ALTERNATES PACKAGE

NOVEMBER 24, 2025

POMPEY PARK  
DELRAY BEACH, FL

# CITY OF DELRAY BEACH POMPEY PARK REC CENTER

DRAWING NO.  
L1.4.1

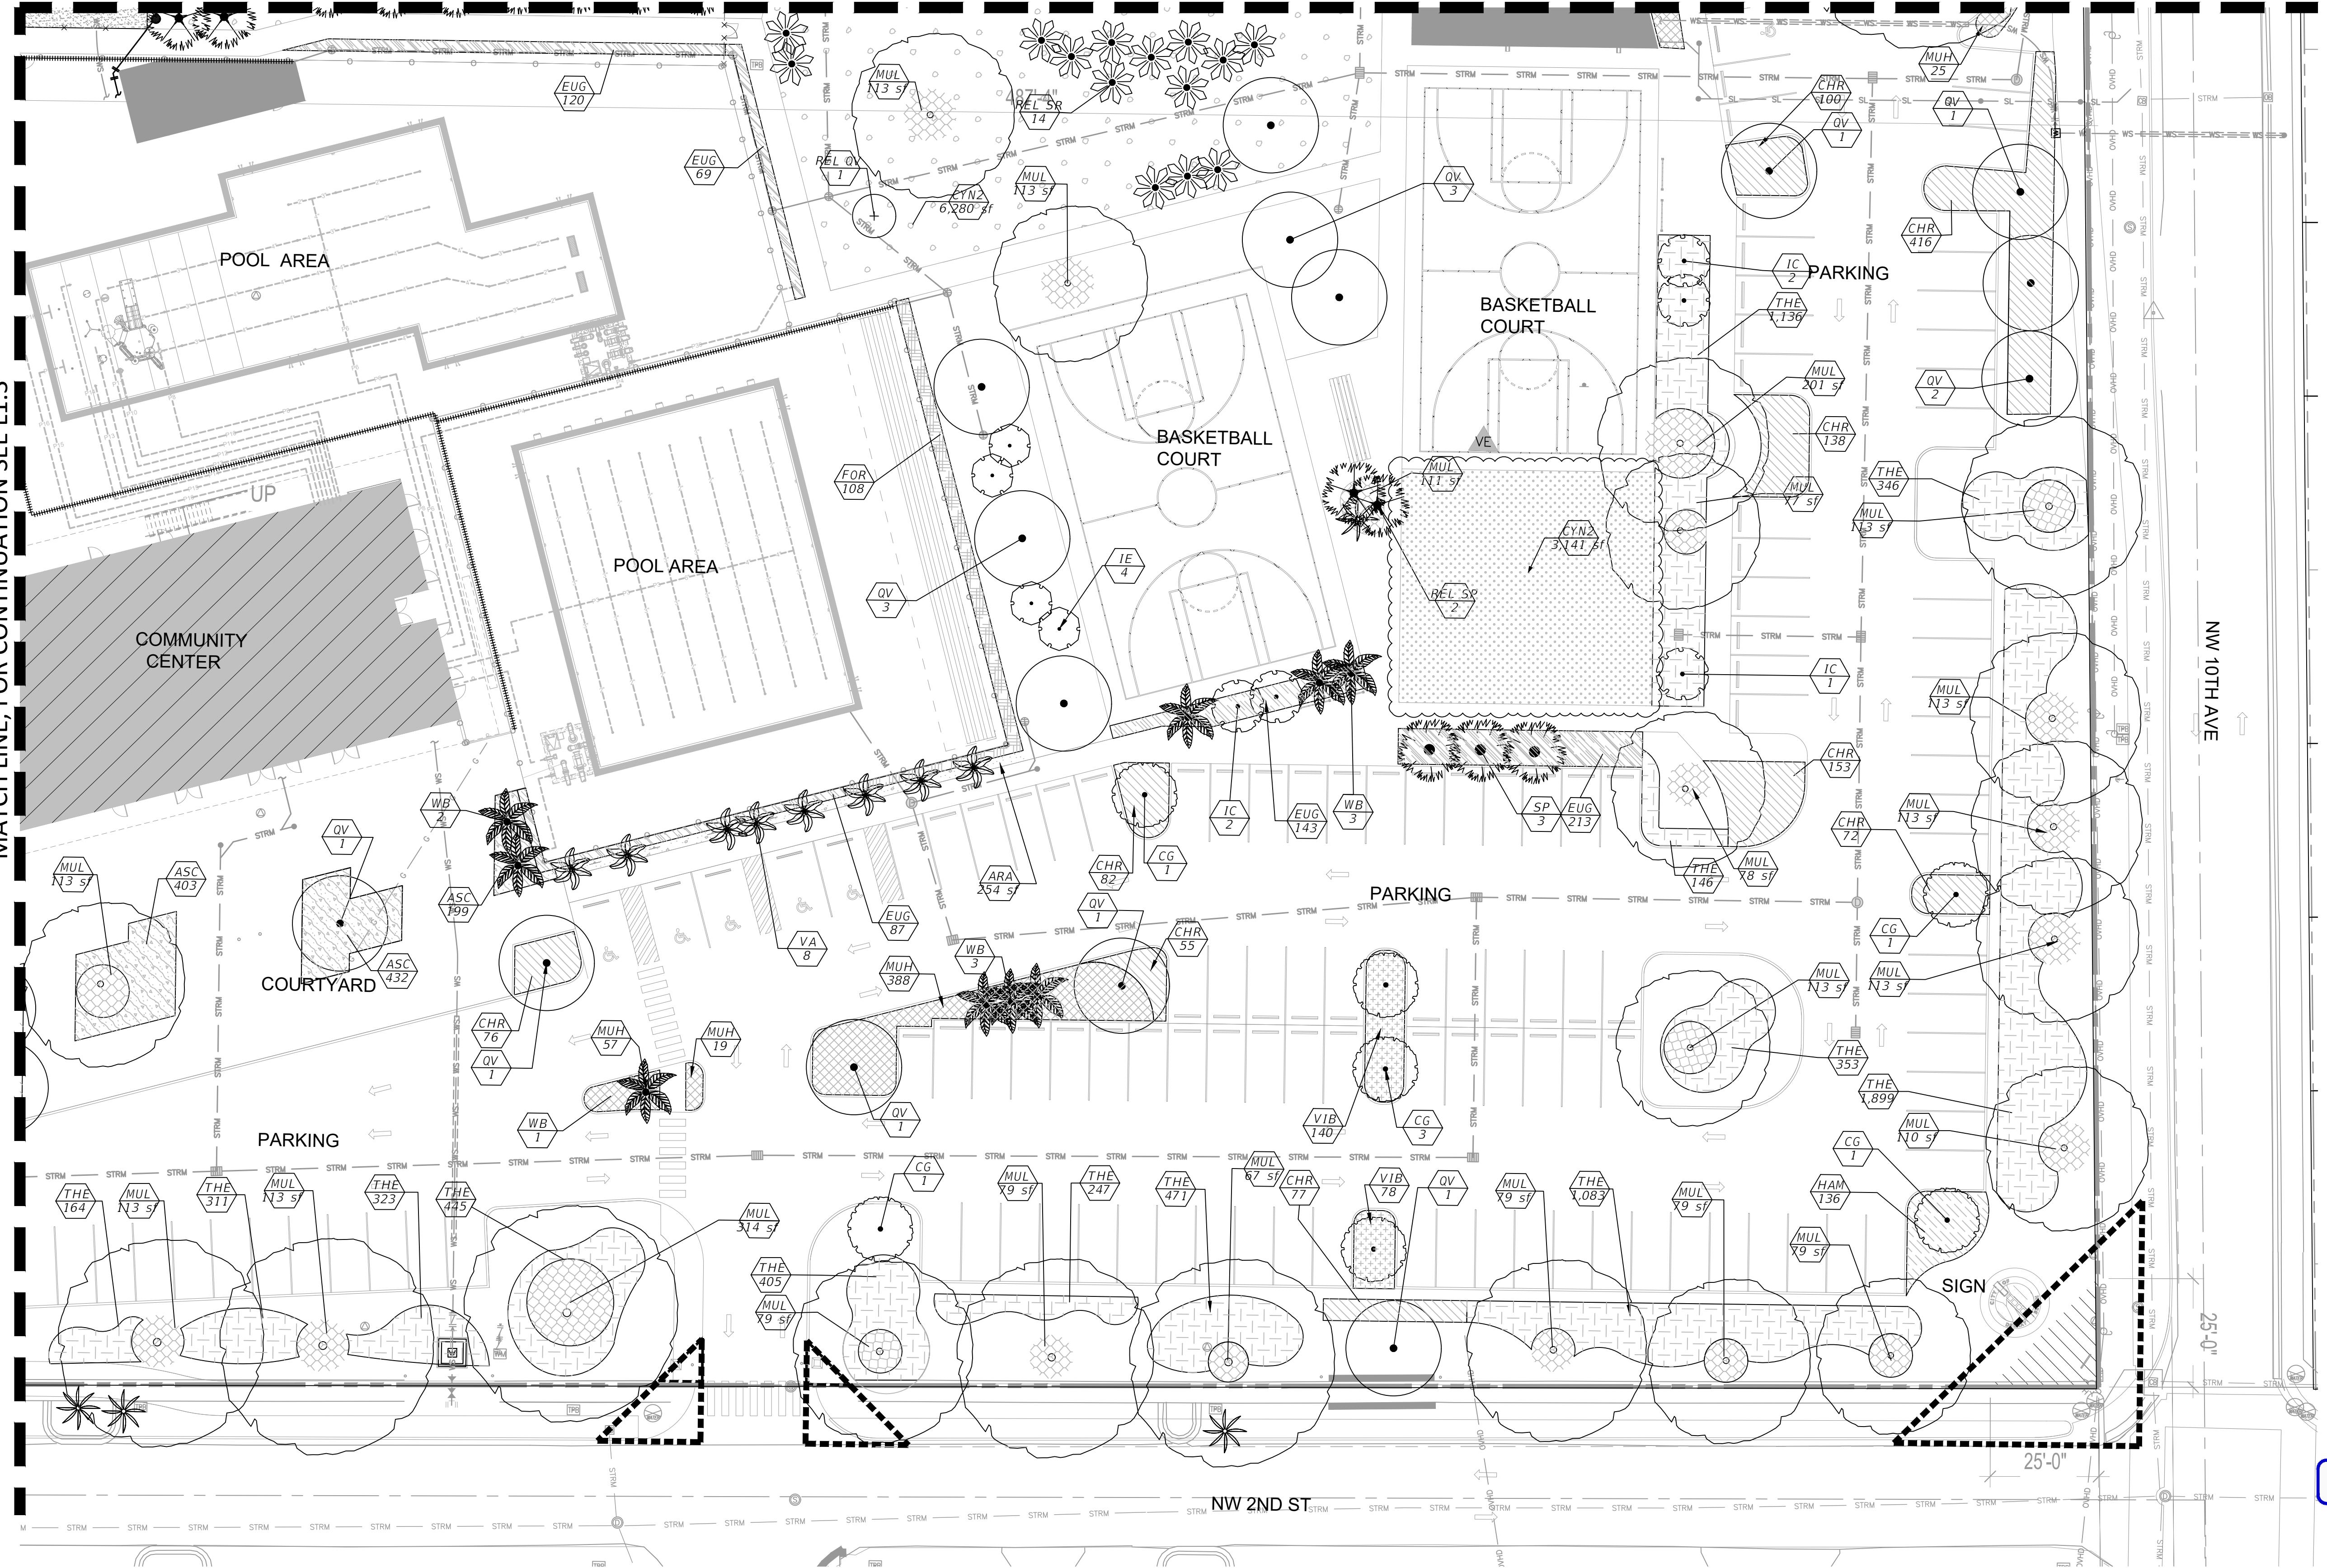
THIS VALUE ENGINEERING PROPOSAL WOULD REMOVE THE HALF BASKETBALL COURT AND REPLACE IT WITH AN OPEN SODDED AREA. THE AREA IS TO BE CLEARED AND REPLACED WITH SOD TO MATCH THE SURROUNDING AREAS. A NEW IRRIGATION ZONE IS TO BE INSTALLED, CONSISTING OF A 1" VALVE, 16 TURF ROTORS, AND THE NECESSARY LATERAL PIPES, SLEEVES, AND MAINLINE ADJUSTMENTS.

CERTIFICATES OF AUTHORIZATION:		
LB6680		
DES.	DWN.	CHK.
PROJECT / FILE NO.		
21-00053		
DRAWING NO.		
IRR1.3.1		
DATE DRAWN:		
11/20/25

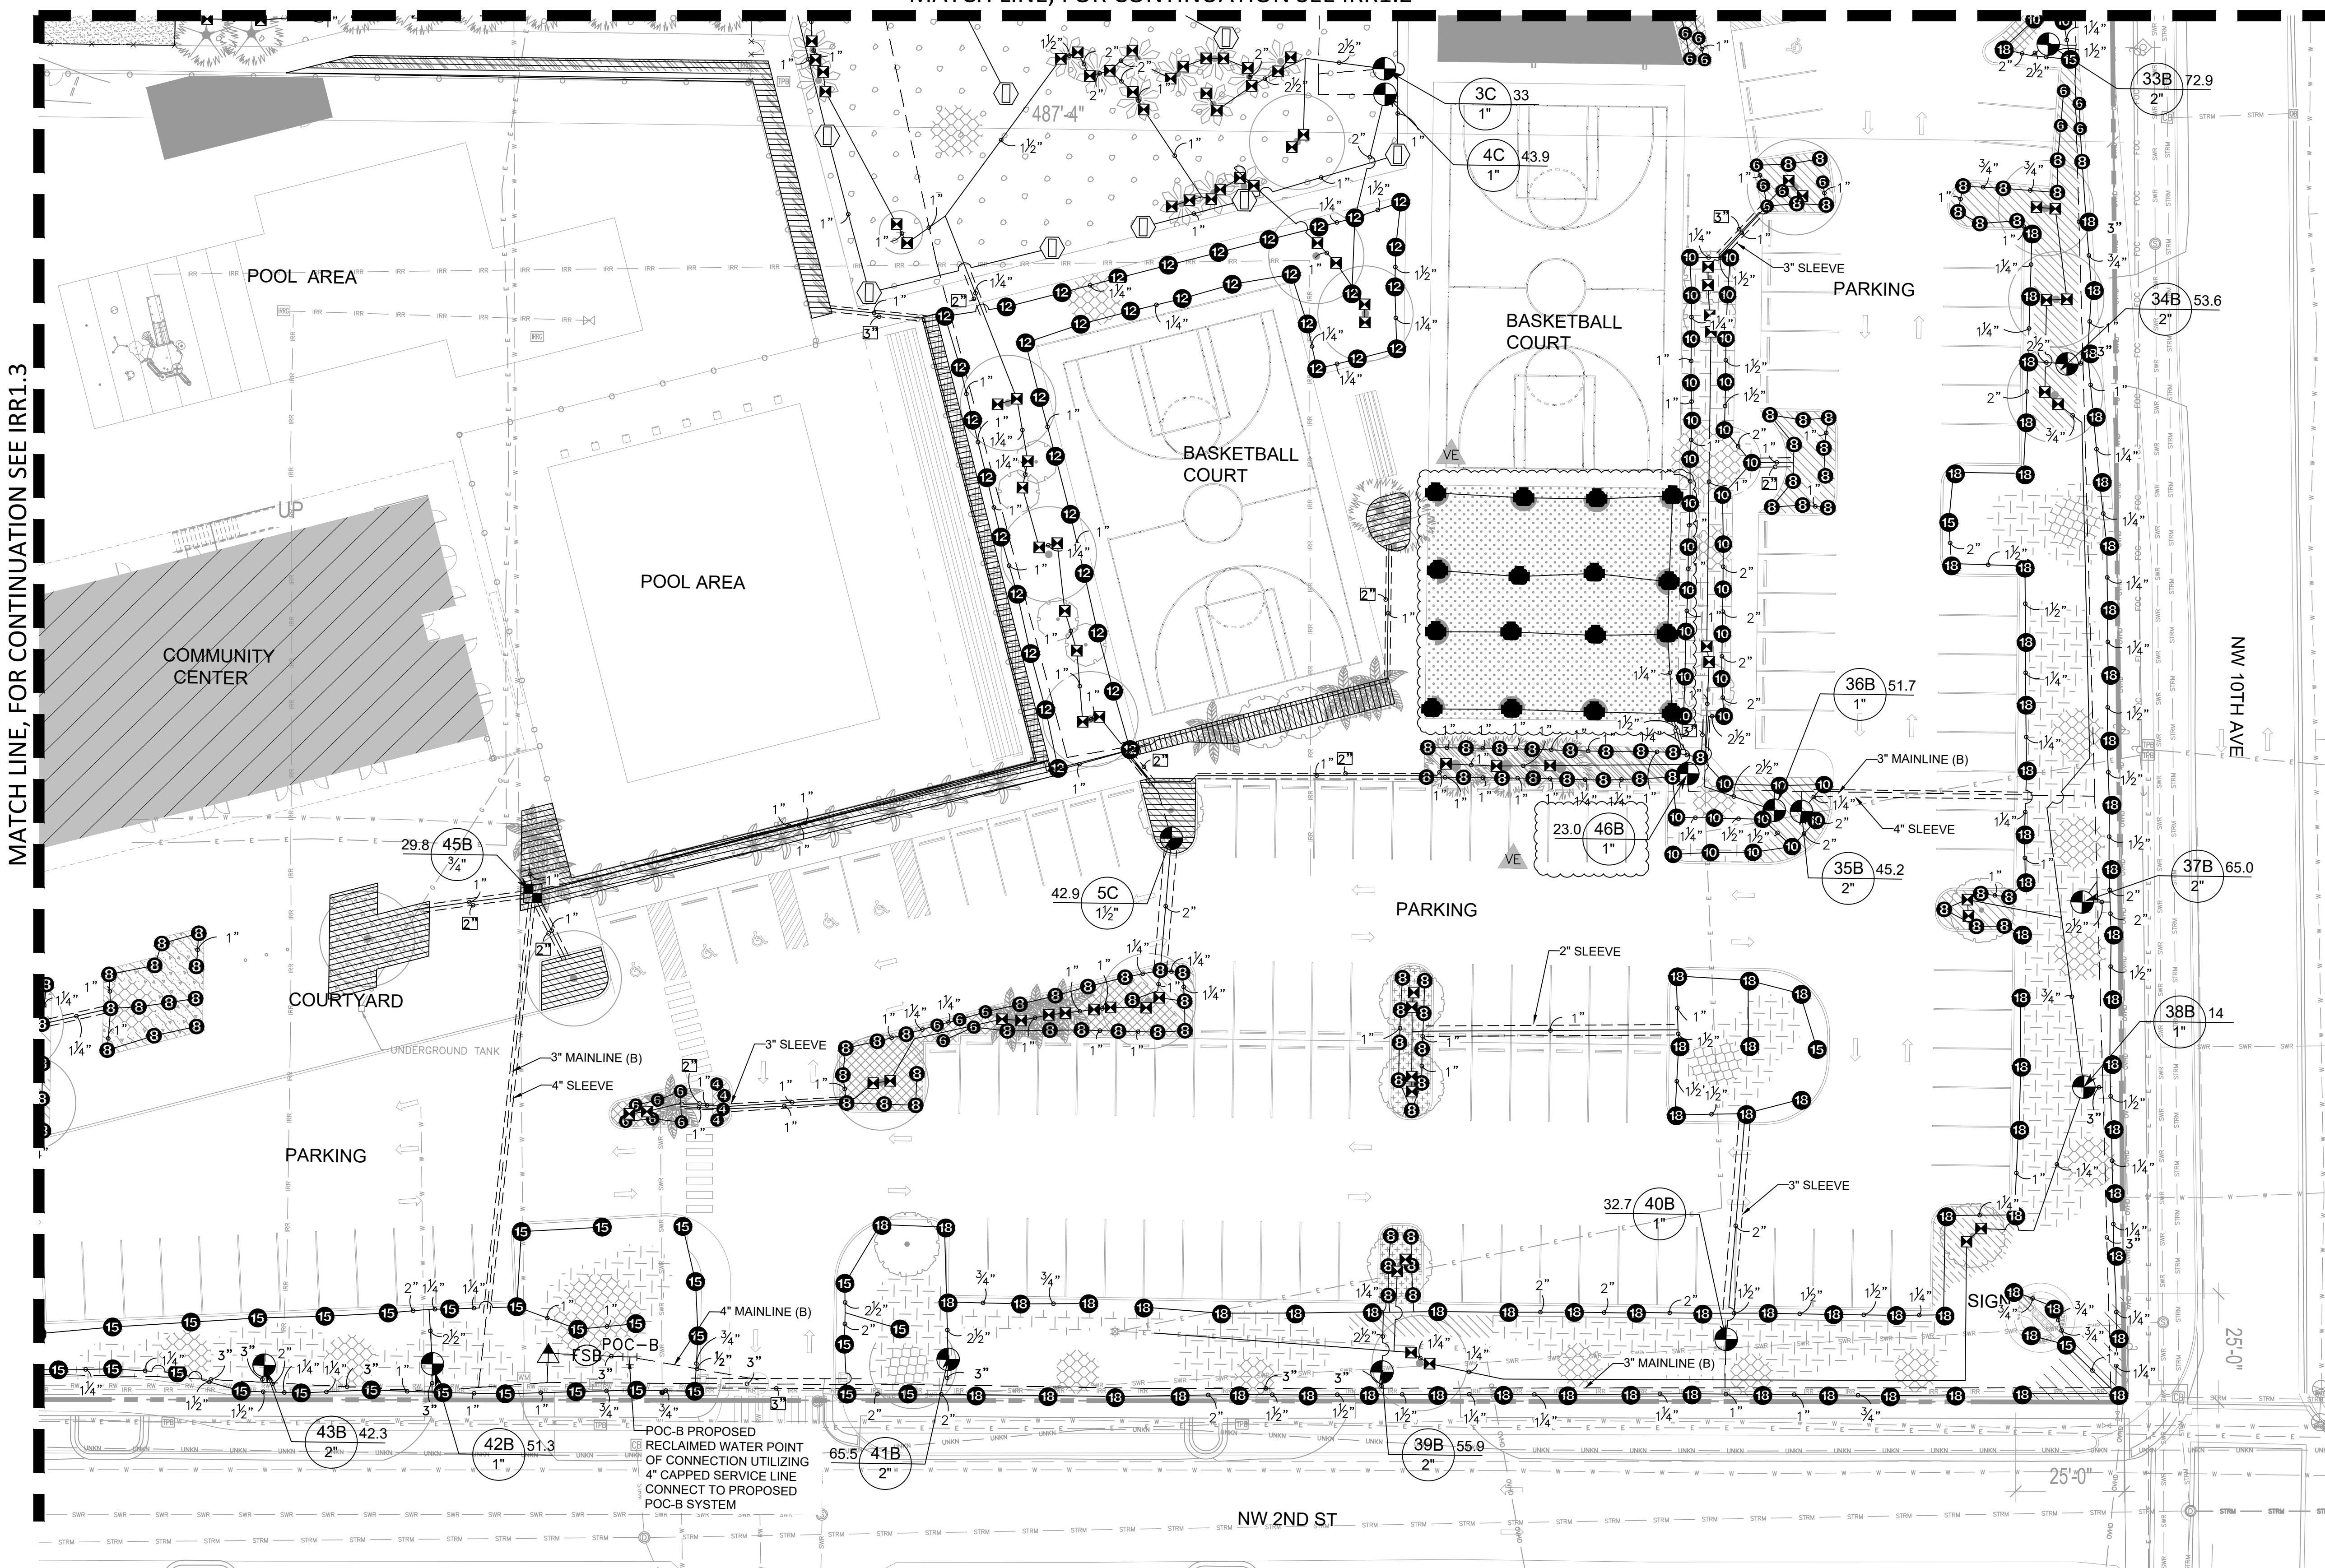
THIS VALUE ENGINEERING PROPOSAL WOULD REMOVE THE FITNESS AREA FROM THE SCOPE OF WORK. FENCING, SURFACING, AND EQUIPMENT WOULD ALSO BE REMOVED FROM THE SCOPE. THE AREA IS TO BE CLEARED AND REPLACED WITH SOD TO MATCH THE SURROUNDING AREAS. A NEW IRRIGATION ZONE IS TO BE INSTALLED, CONSISTING OF A 1½" VALVE, 21 TURF ROTORS, AND THE NECESSARY LATERAL PIPES, SLEEVES, AND MAINLINE ADJUSTMENTS.

CERTIFICATES OF AUTHORIZATION:		
LB6680		
DES.	DWN.	CHK.
PROJECT / FILE NO.		
21-00053		
DRAWING NO.		
H1.3.1		
DATE DRAWN:		
11/20/25

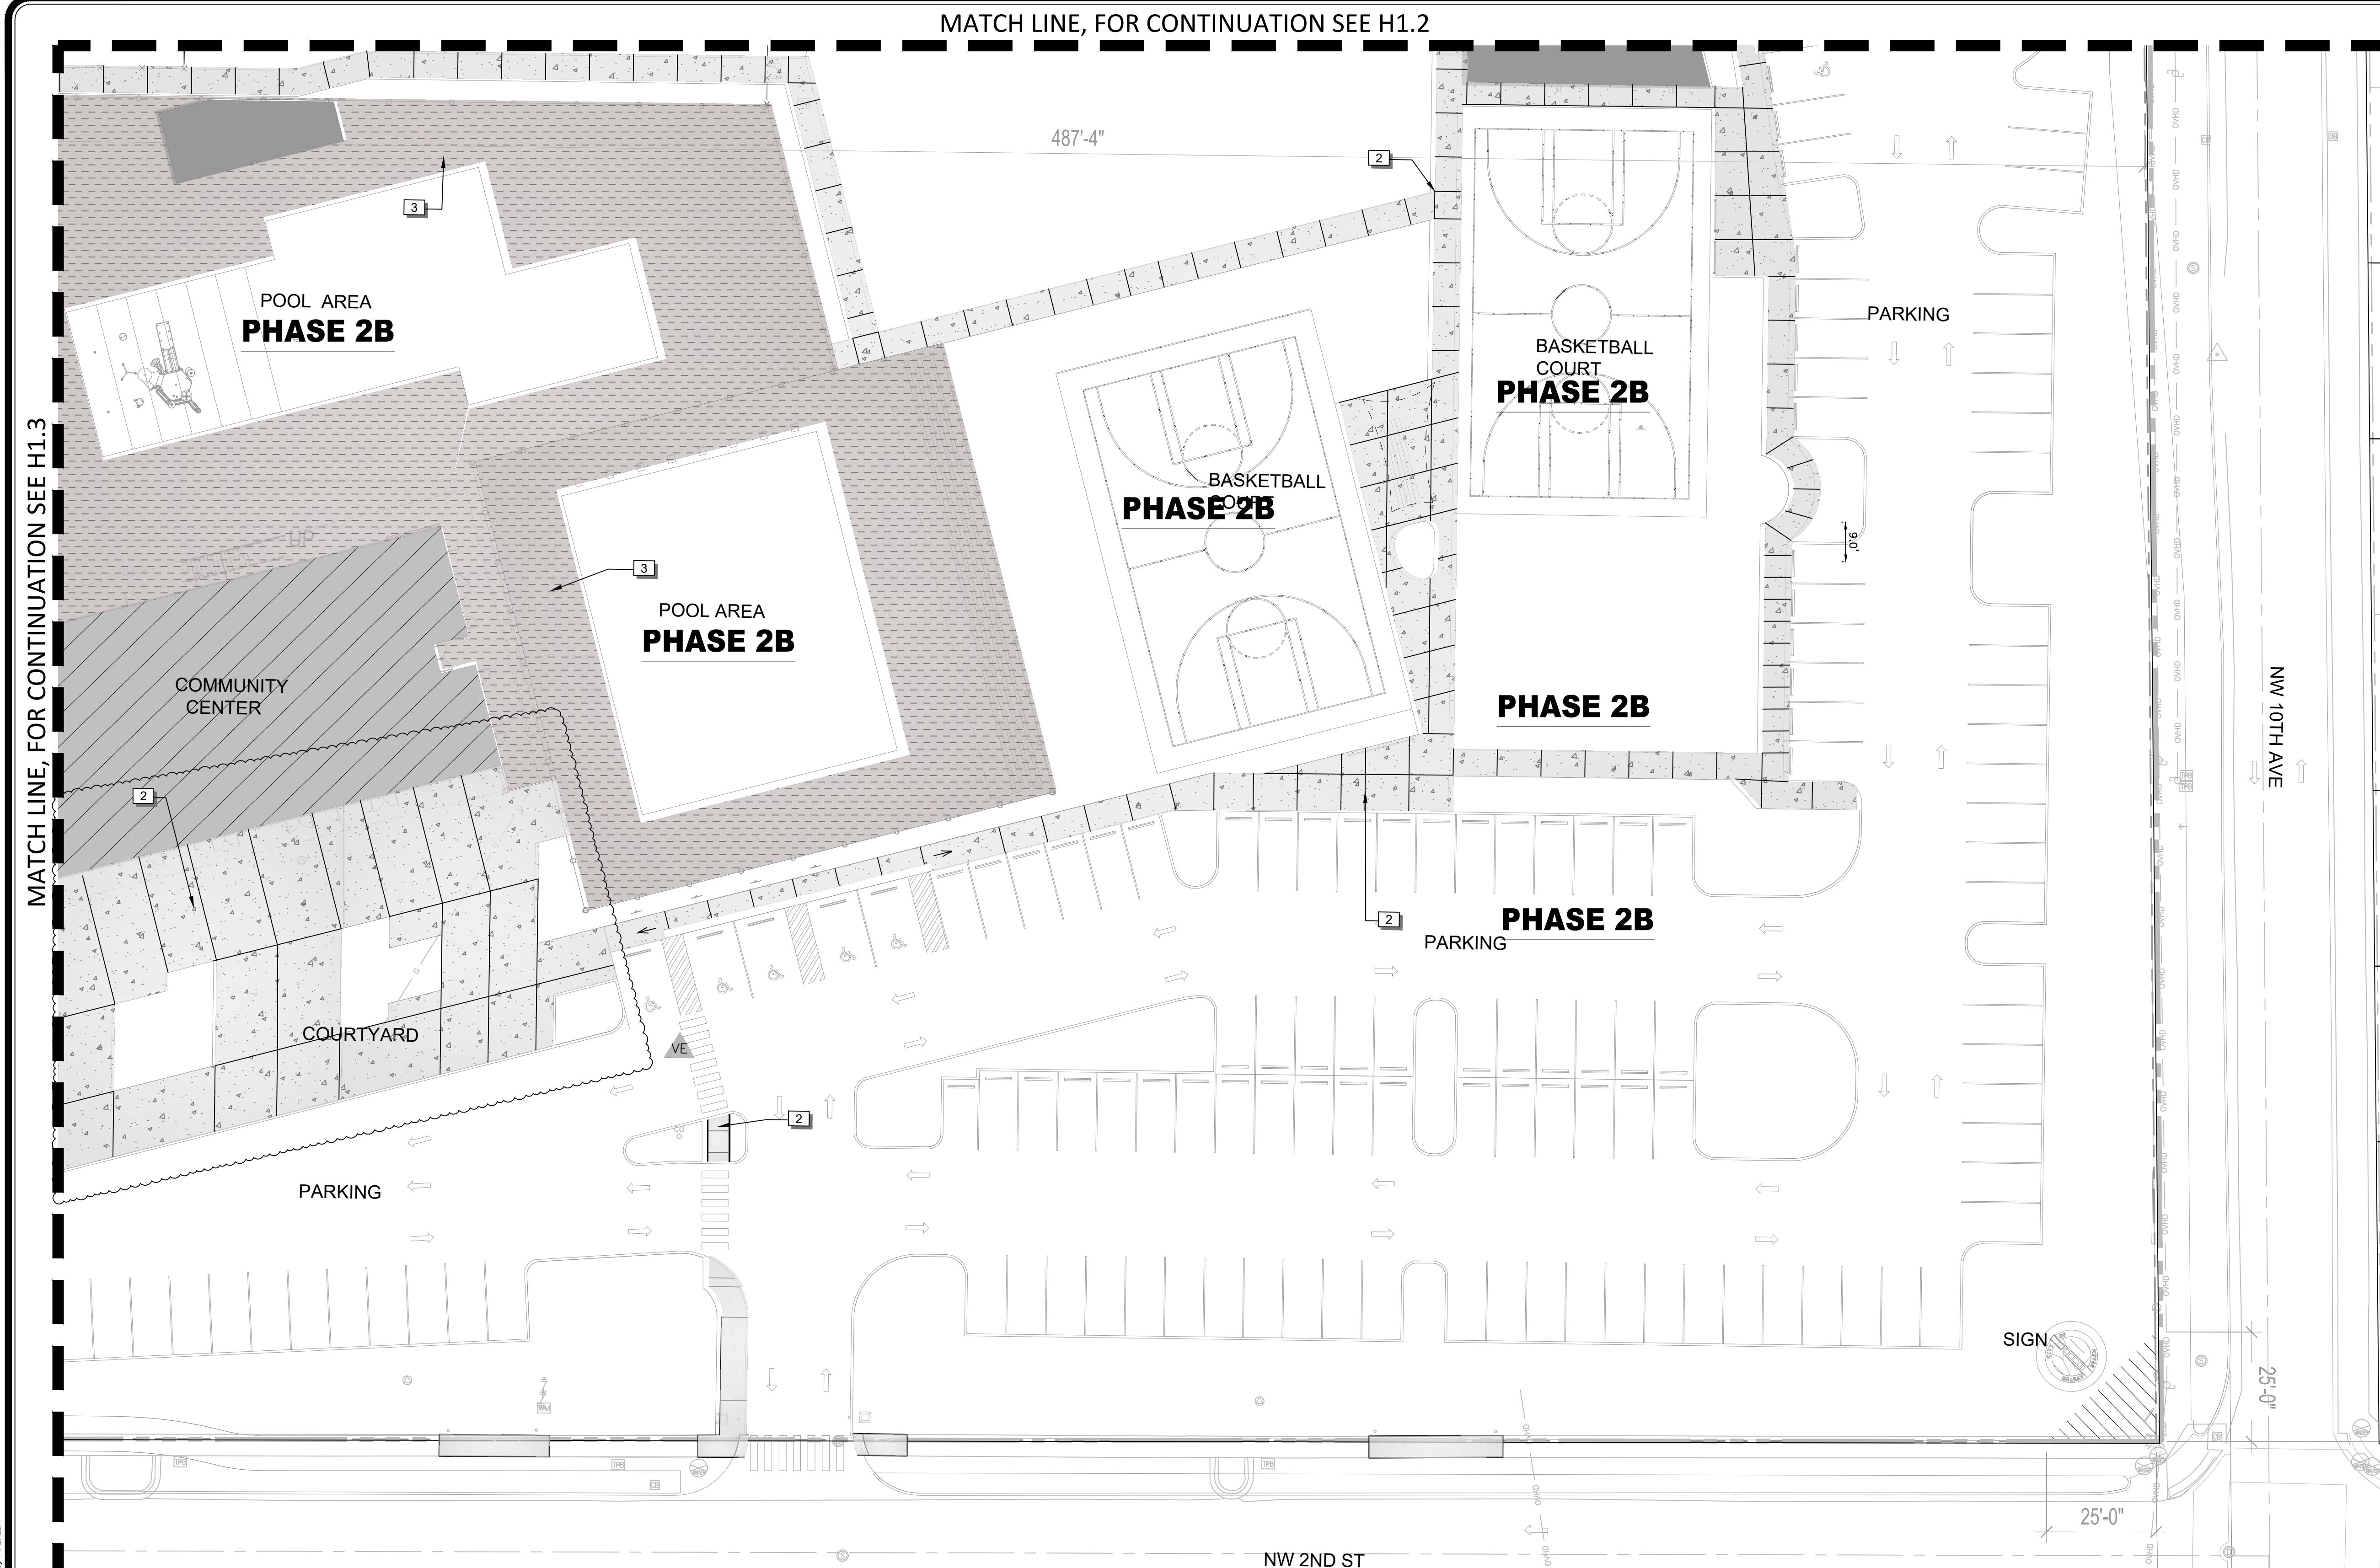
AS PART OF THIS VALUE ENGINEERING PROPOSAL, THE 5" THICK ROCK SALT-FINISH CONCRETE SIDEWALKS WITH ANGLED SAWCUT PATTERNS, AS SHOWN IN THE BASIS OF DESIGN CONSTRUCTION DOCUMENTS, WILL BE REPLACED WITH 4" THICK STANDARD BROOM-FINISH CONCRETE. THE EXTENTS OF THIS CHANGE ONLY INCLUDE THE ENTRY PLAZA ON THE SOUTH SIDE OF THE BUILDING, REFER TO ITEMS SHOWN ON SHEETS H1.3, H1.4 AND H1.5. JOINTS SHALL BE PROVIDED AS REQUIRED TO MAINTAIN STRUCTURAL INTEGRITY AND PERFORMANCE.
